## Homestead Neighborhood Association

Re: Barbur Bike Lanes and realignment of vehicular traffic on Barbur at Hamilton Street

Re; S.W. Barbur Blvd. Proposals

Project title sheet

. Holy and de S.W. W. S. W S.W. Lane St. Raised Pedestrian S.W. Barbur Refuge A Begining of bike bis Street Light (Typical) Lane/View Point/Barbur Barbur Bike Lane Intersection Blvd. <u>}</u> To Downtown

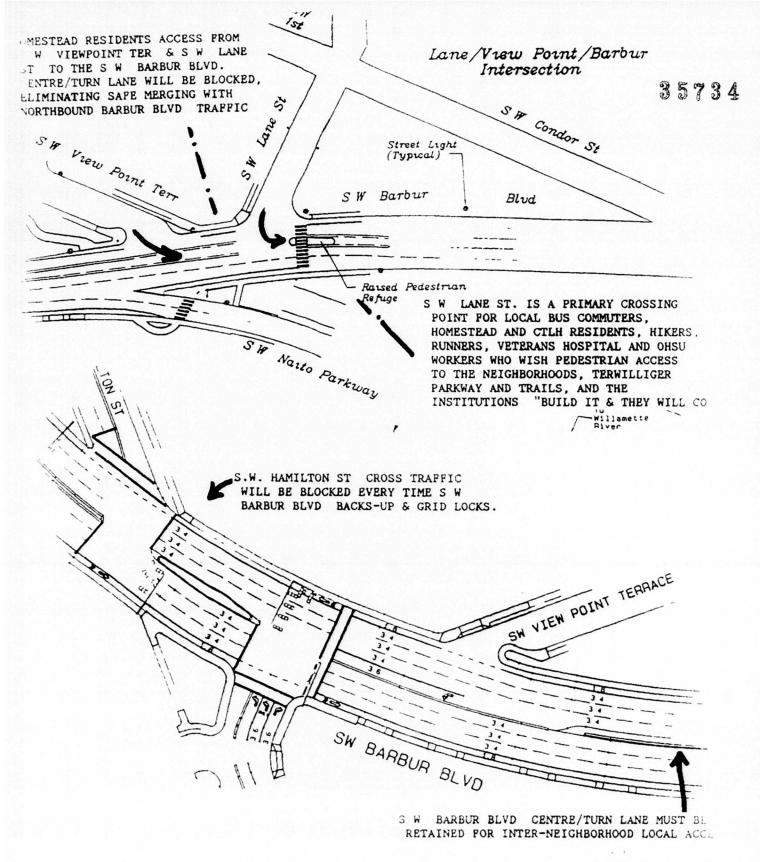
- a The intersection at Lane will have a raised safety island on Barbur north of Lane.
- b. Cars coming up from Corbett to the Hamilton-Barbur intersection will enter at a right angle (north of its present location), requiring two turns to go up to Terwilliger

c The right-hand turn west of Swan Market will be eliminated but cars will be able to enter its parking lot from both Hamilton and Barbur

d The bus stop will be moved from the island in front of Swan Market across Hamilton to a new plaza in front of the church.
